Meadowbrook Park

**PUD Development Plan, Preliminary Plan, Pre-Development Site Grading &
Wet Utilities**

Letter of Intent

Modified **"Celeste Heights (from STA 11+50 to end), Tenebris Point, & Lux Point"** Cross Section:

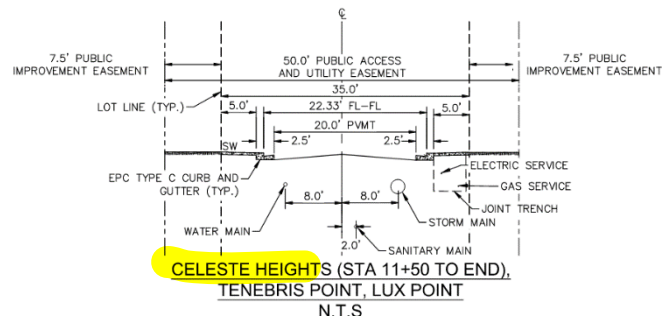
Revise the names on the ALL roadways to match what is shown on the updated PUD plan.

Modified "**Celeste Heights**" (from STA 10+37.00 to STA 11+50.00) Cross Section:

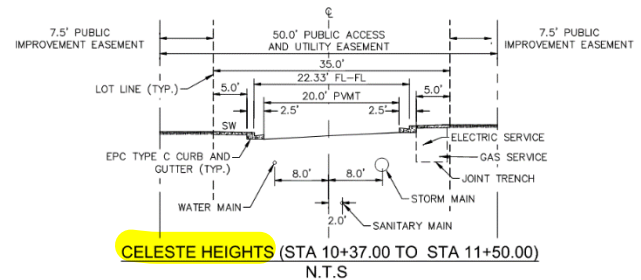
Text line not needed.

Modified "**Solum Grove**" Cross Section:

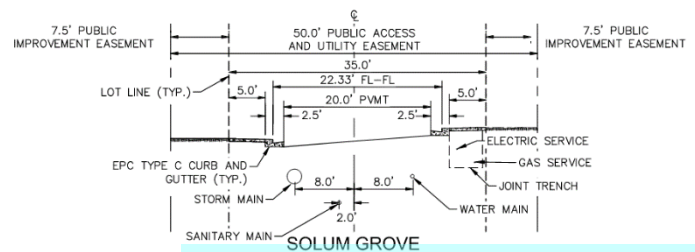
Please revise this sentence accordingly as indicated on the response document provided.
